NOTICE OF DECISION

**CLASS 3 SITE PLAN REVIEW / CLASS 2 ADJUSTMENT / CLASS 2 DRIVEWAY
APPROACH PERMIT / CLASS 1 DESIGN REVIEW CASE NO.: SPR-ADJ-DAP-
DR24-03**

APPLICATION NO.: 23-114721-PLN

For property approximately 0.74-acre property is zoned MU-III (Mixed Use-III) and located at 1250 Baxter Road SE (Marion County Assessor's Map & Tax Lot No.083W14BC / 5400).

SITE PLAN

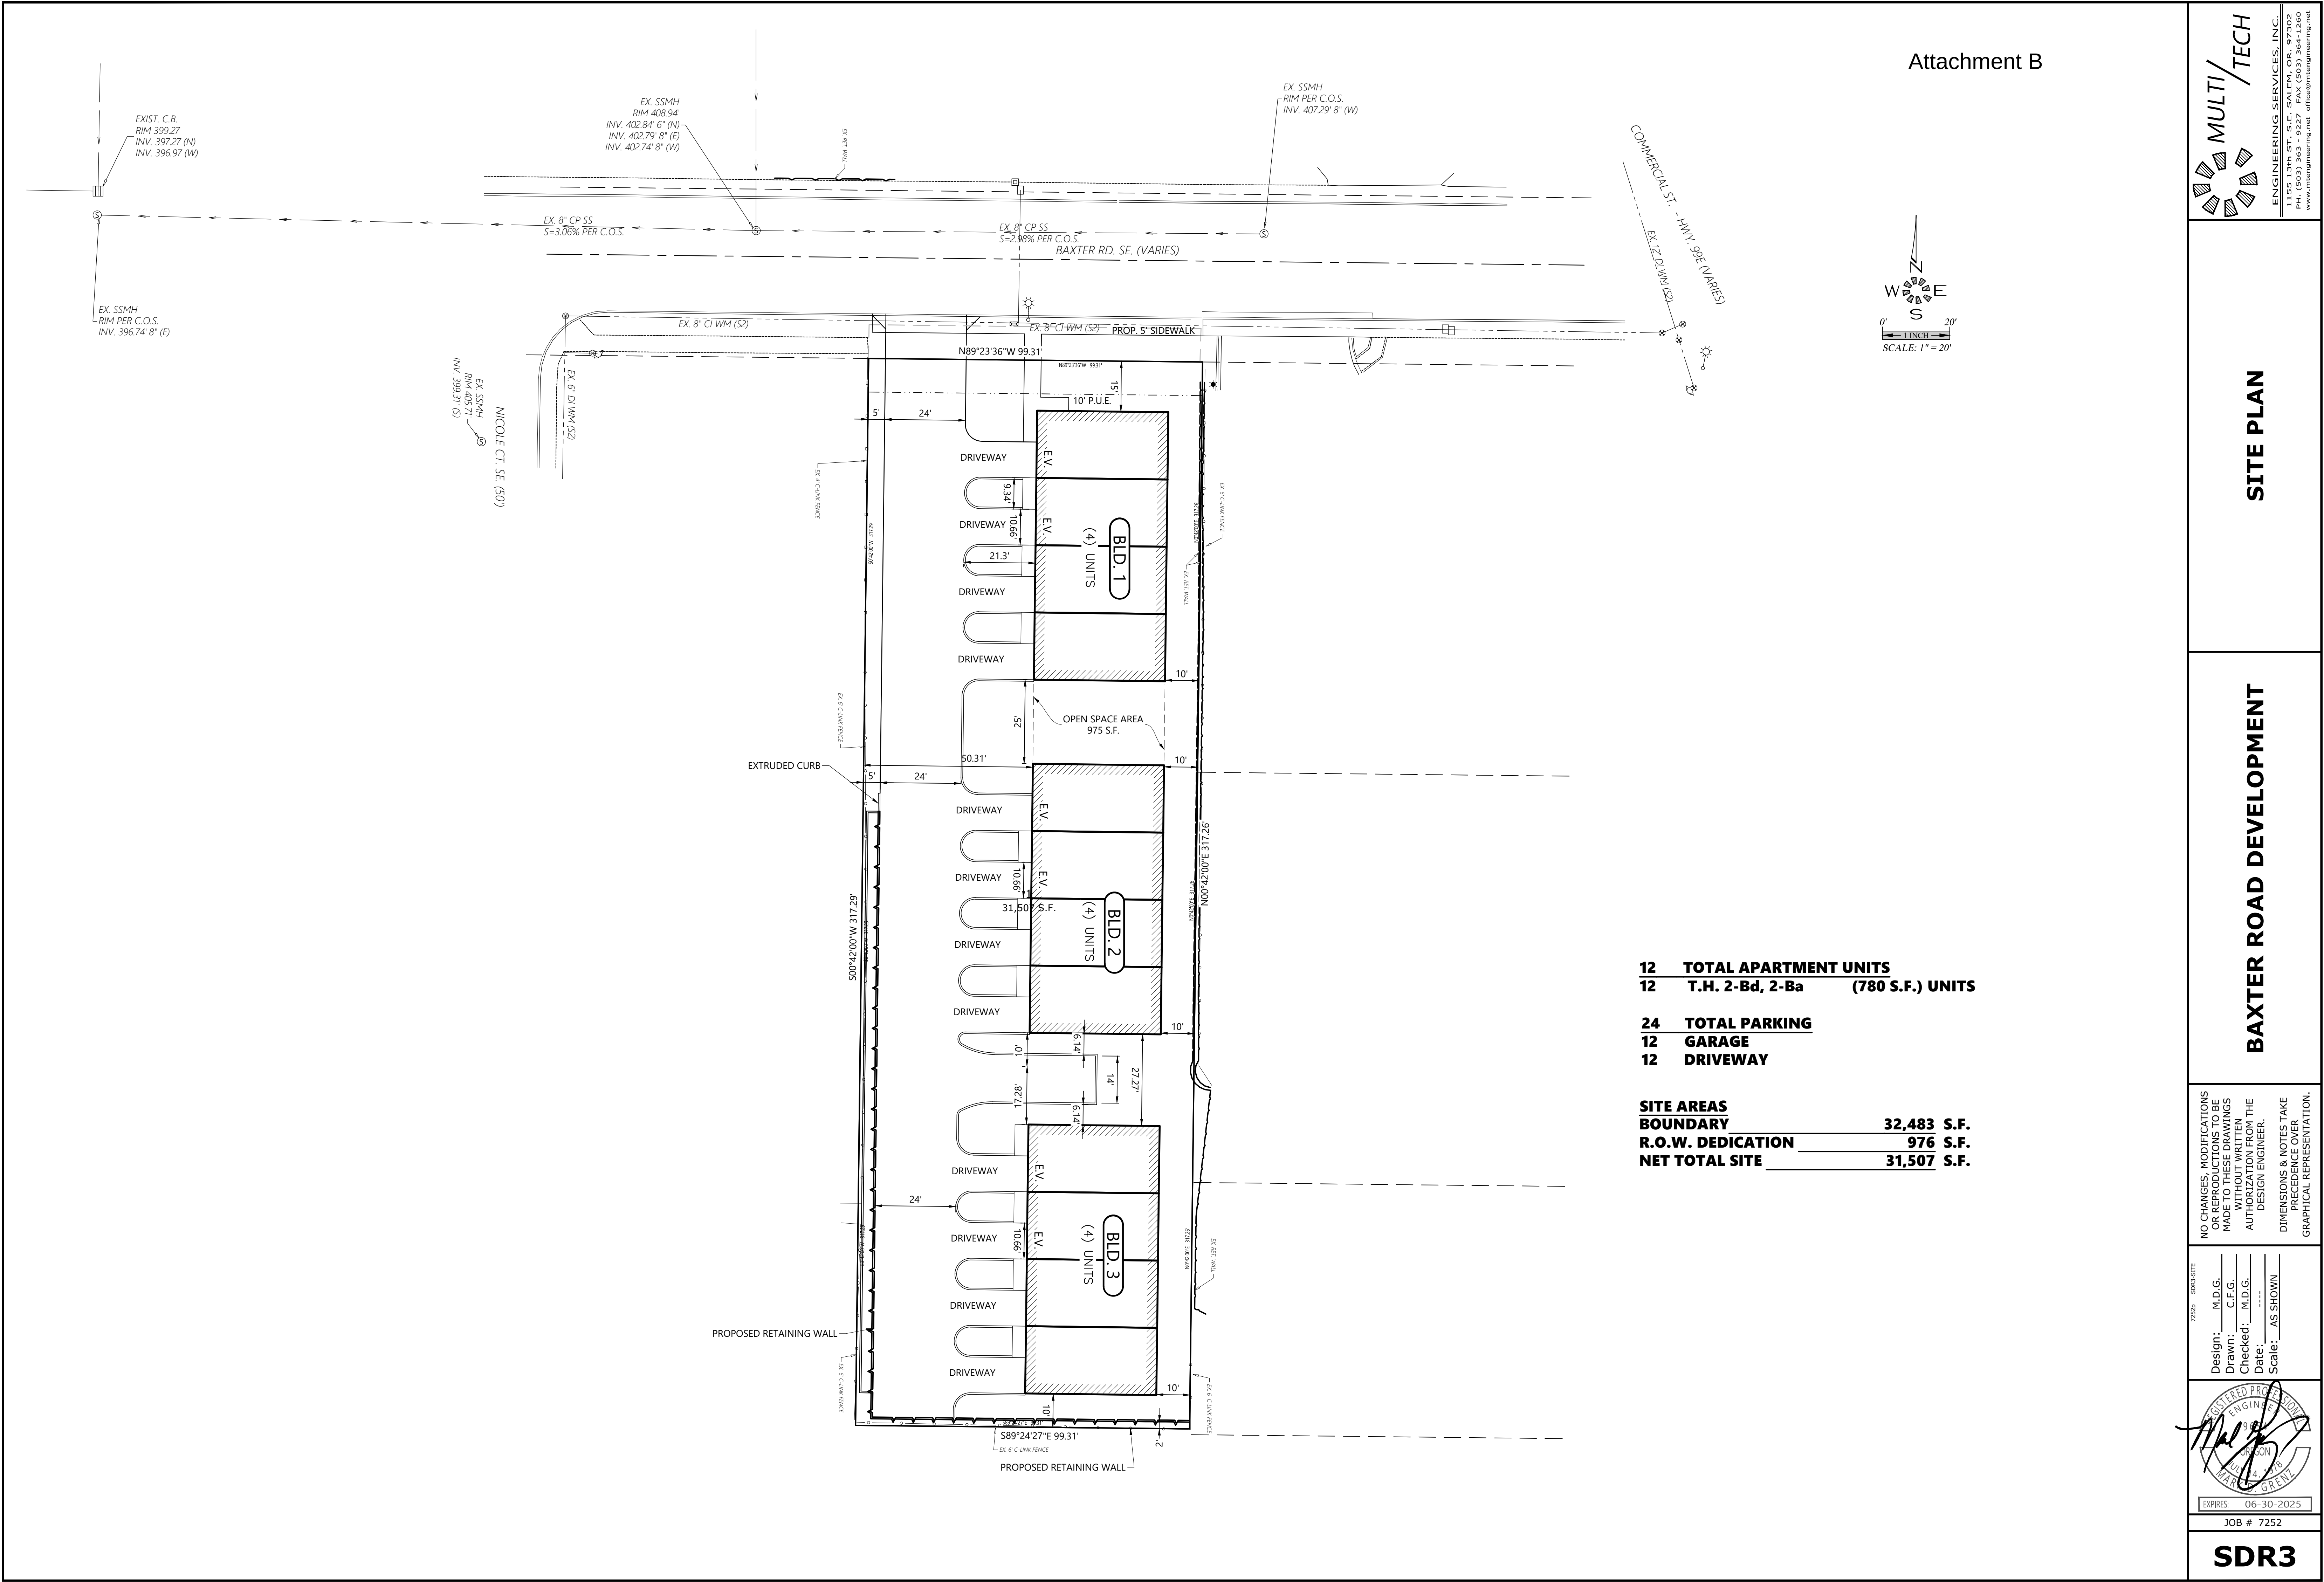
The applicant's elevations and floor plans do not clearly demonstrate compliance with the ground-floor window standards of this section. As a result, the following condition applies:

Finding: The proposed development includes 12 dwelling units and 12 parking spaces. Twelve parking spaces requires a minimum of five electric vehicle charging spaces ($12 \times 0.4 = 4.8$). The development plans do not indicate that electric vehicle charging spaces will be provided; therefore, the following condition applies:

Finding: As shown on the site plan, the proposed development includes a drive aisle that serves individual driveways. The drive aisle terminates in a dead-end. A vehicle turnaround is shown on the applicant's site plan with the dimensions of 24x7.5x0, which does not meet the minimum dimensional standard of 24x6x9. To ensure compliance with the requirement of this provision, the following condition shall apply:

The development proposal includes approximately 6,553 square feet of setback area where one plant unit is required for every 20 square feet, requiring 328 plant units. The site includes approximately 1,050 square feet of setback area where one plant unit per every 16 square feet is required, totaling 66 plant units. Together the setbacks require a minimum of 394 plant units. Of the 394 required plant units, 40 percent (158 plant units) must be trees. The applicant's submitted plans do not indicate conformance with these standards. However, Condition 2 above ensures that all landscaping requirements of SRC 535, 702, and 806 be met prior to building permit approval. As conditioned, this standard is met.

Finding: The development plans do not adequately demonstrate that all habitable rooms that face common open space, parking areas, and pedestrian paths will have windows and therefore do not meet the standard. To ensure that site safety and security is maintained, the following condition applies:

Finding: The applicant's written statement indicates lighting will be provided along the buildings and pedestrian paths within the development in accordance with this standard. The development plans, however, do not show lighting in any locations. To ensure the standard is met, the following condition shall apply:

- Condition 3:** Prior to building permit issuance, the applicant shall submit building elevations and floor plans demonstrating compliance with the ground-floor window standards of SRC 535.015(g)(5).

Condition 4: Prior to building permit issuance, the applicant shall submit plans demonstrating compliance with the minimum number of equipped electric vehicle charging spaces as established in SRC 806.015(d). The proposed development is required to install five electric vehicle charging spaces.

Condition 5: Provide a vehicle turnaround space meeting the dimensions of SRC 806.035(f)(2), Table 806-9 for turnaround that terminates at a dead-end on the south side of the development site.

Condition 16: Prior to building permit issuance, the applicant shall submit building elevations and floor plans clearly demonstrating that windows are proposed in all habitable rooms, except bathrooms, on each wall that faces common open space, parking areas, and pedestrian paths, meeting SRC 702.015(c)(1).

Condition 17: Prior to building permit issuance, a lighting plan shall be provided which demonstrates all exterior dwelling unit entrances, parking areas, and pedestrian paths will be illuminated.
